# Anita Bay Corridor Quality Assurance Report of DOT Roads to Resources Project

**Technical Report** · July 2015

**Alaska Department of Transportation  
Roads to Resources Project  
LiDAR & Imagery  
Quality Assurance Report  
Anita Bay**

**Written by Rick Guritz  
Alaska Satellite Facility  
July 30, 2015**

Figure 24, Canopy Height Classification.

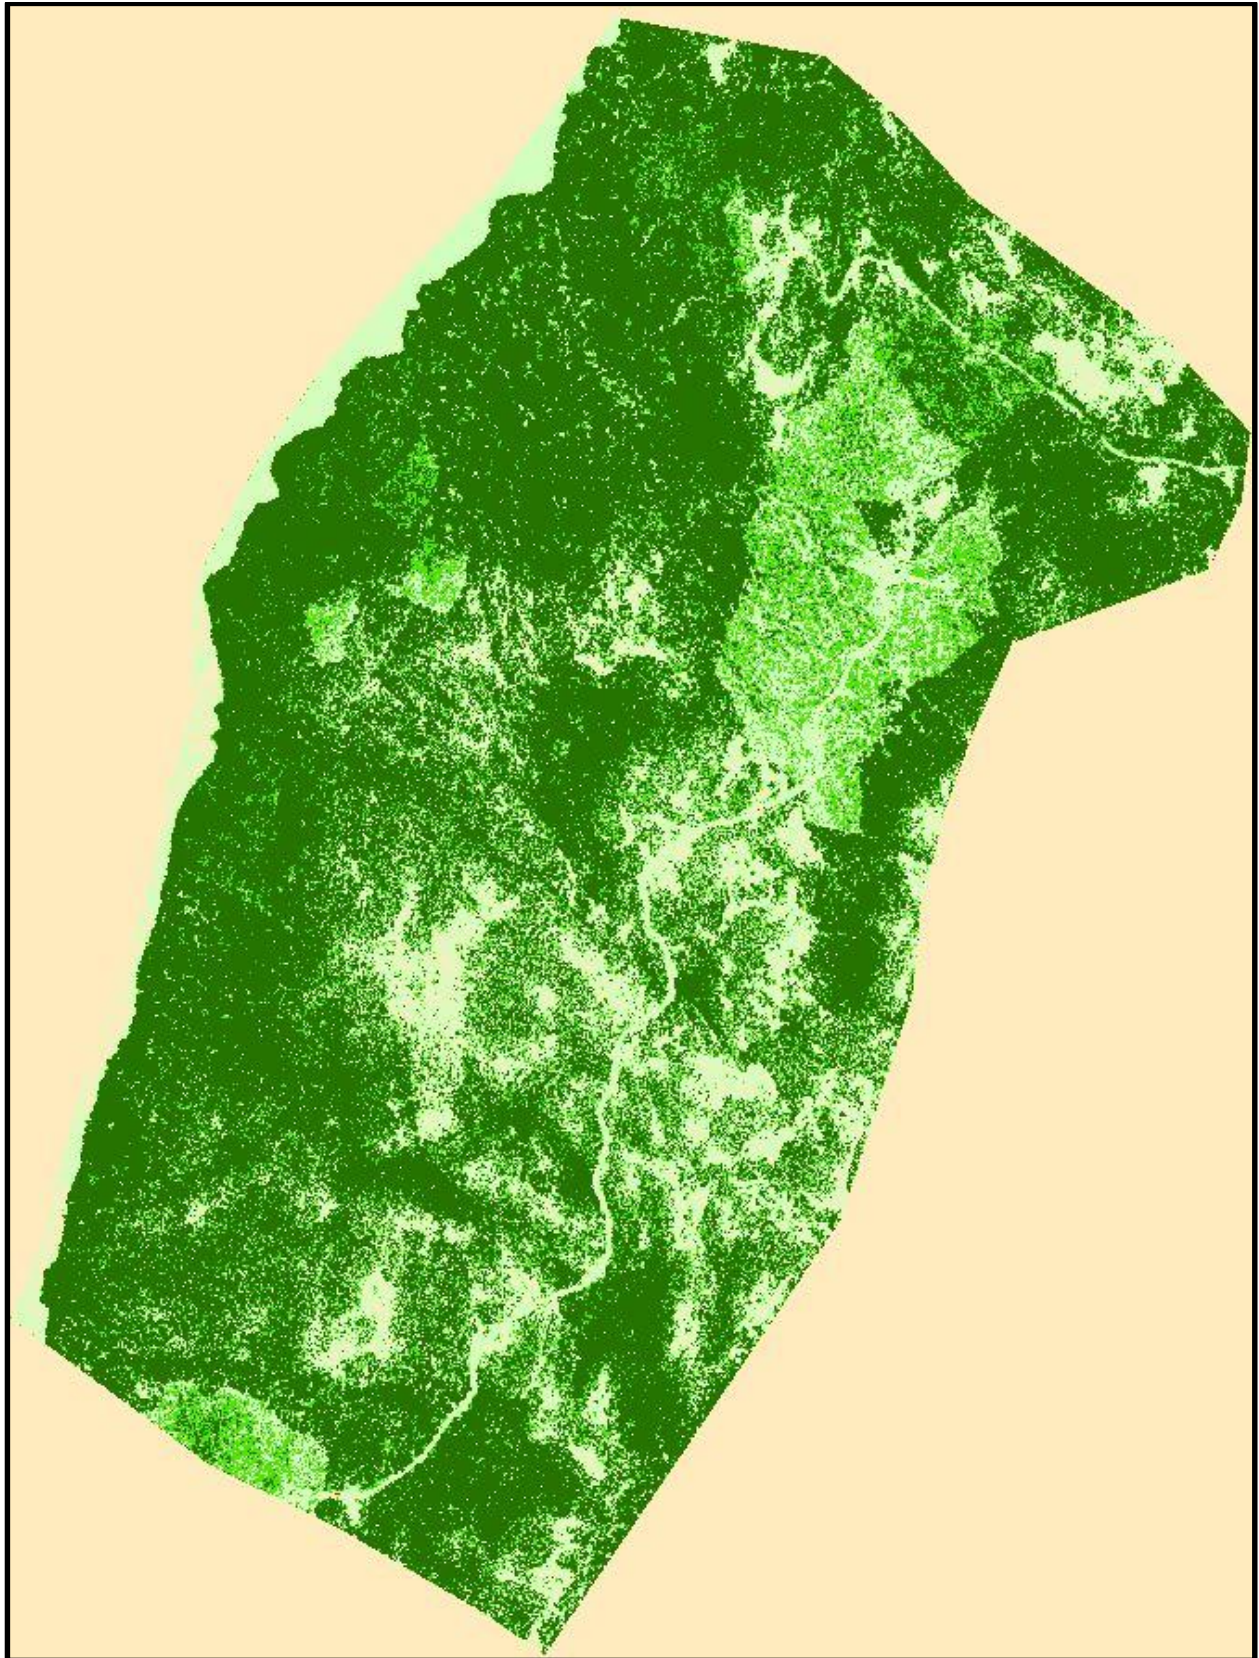
Cross validation analysis was performed between each of the class layers and other source data. For example, a canopy height can be estimated by subtracting the bare-Earth surface DEM from the first-return DSM. This product could then be colorized based on a number of classifications to match each of the three vegetation layers (see Figure 24), i.e. 0-6 feet for low vegetation (light green), 6-15 feet for medium vegetation (medium green), and greater than 15 feet for high vegetation (dark green). Barren ground could have height differences from -1 to 1 foot. Other classes could draw attention to outlier heights such as values less than zero (red) and values greater than the tallest expected tree height (violet). The LiDAR point model stack product was compared to the canopy height classification product to verify consistency of data between LiDAR point cloud data and raster gridded data products. It should be pointed out that the graphic display of point data in Quick Terrain Modeler is different than displaying raster classification products in ArcMap, so some differences are expected, it gives a good idea of consistency of coverage in both products. **Height errors were found in the canopy height classification in Anita Bay Corridor that needed to be fixed by Tetra Tech.**

Figure 29, Black holes in ground surface are where there is lack of penetration to the ground. Since both LiDAR point density and swath overlap look good, this must be due to thick ground vegetation.

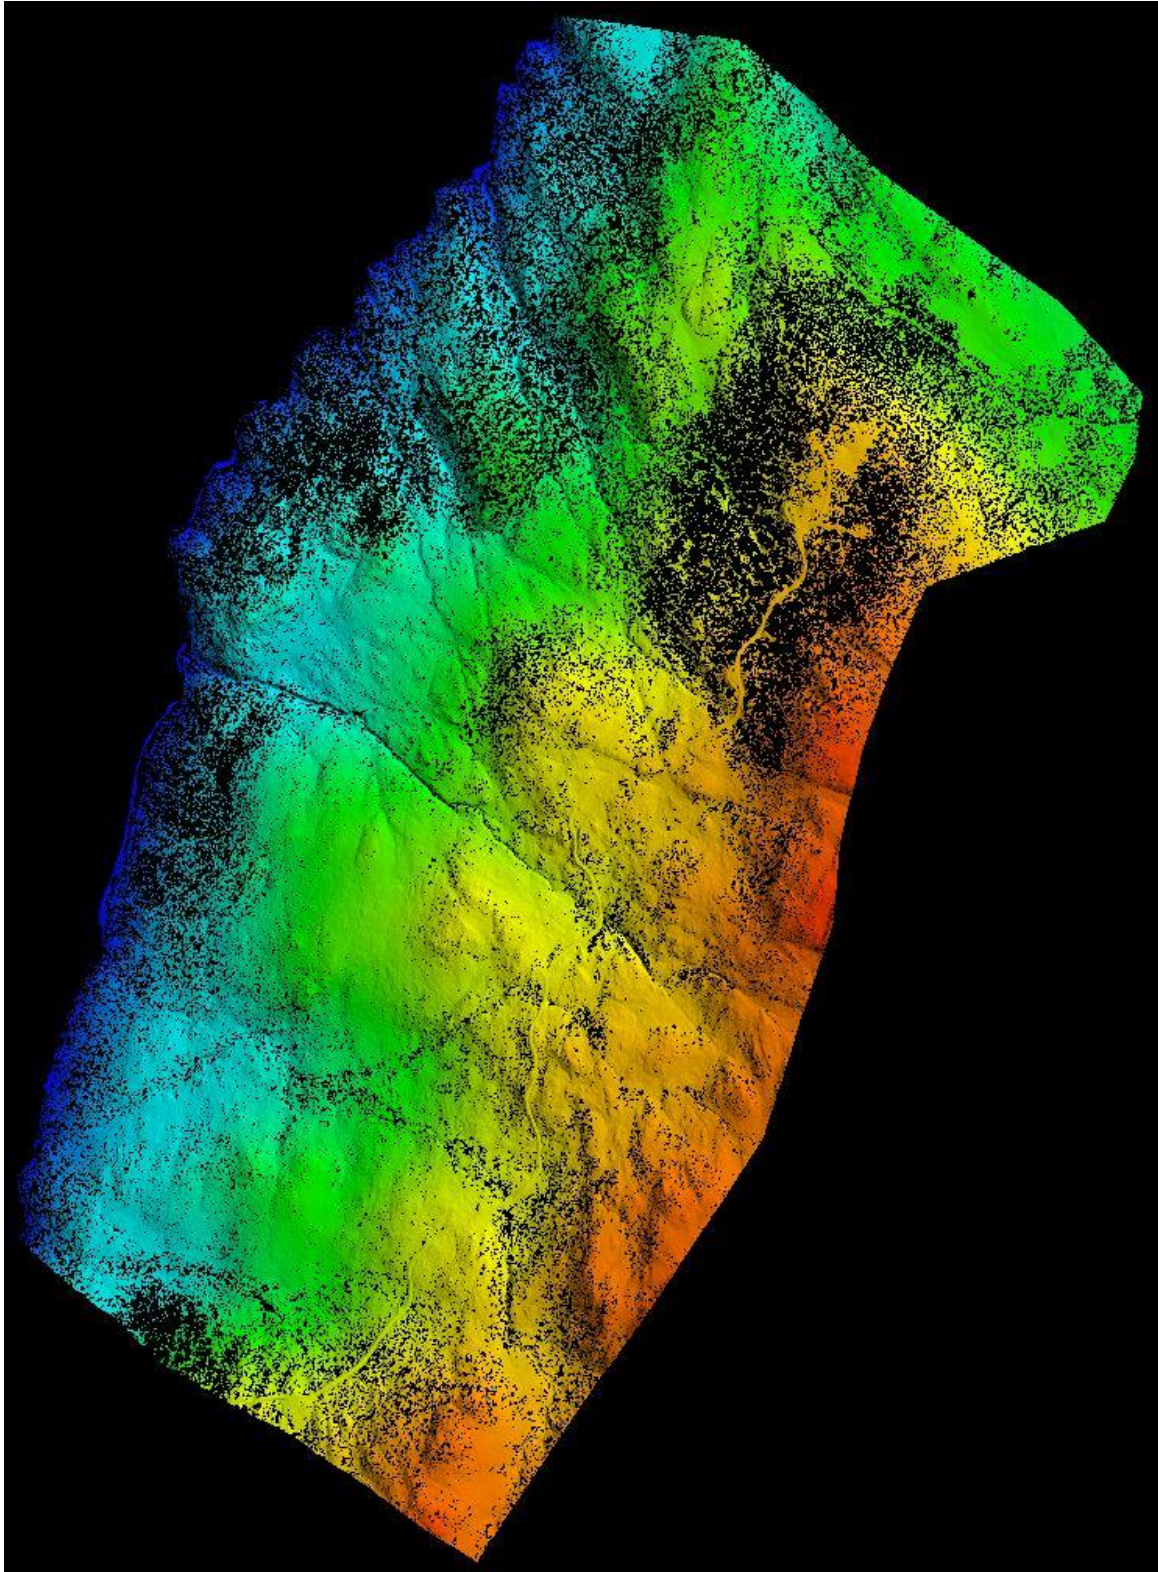
**UAF reported some concerns regarding lack of ground points** – On 3/18/2015, UAF reported some concern over the amount of ground points observed for Anita Bay. When I combine class 2 - ground points with class 8 - ground model keypoints, there is some areas that are pretty dark in the QTM display. This is when displaying the point data without a triangulated fill. Discussed with Dan Ignatov and decided to accept as is if both LiDAR point density and swath overlap meets specification.

**UAF reported completion of swath overlap analysis** – On 3/18/2015, UAF reported completion of its swath overlap analysis of Anita Bay. This completes UAF LiDAR assessment. Poor ground penetration must be due to dense ground vegetation. We await GINA completing its ortho-imagery assessment.
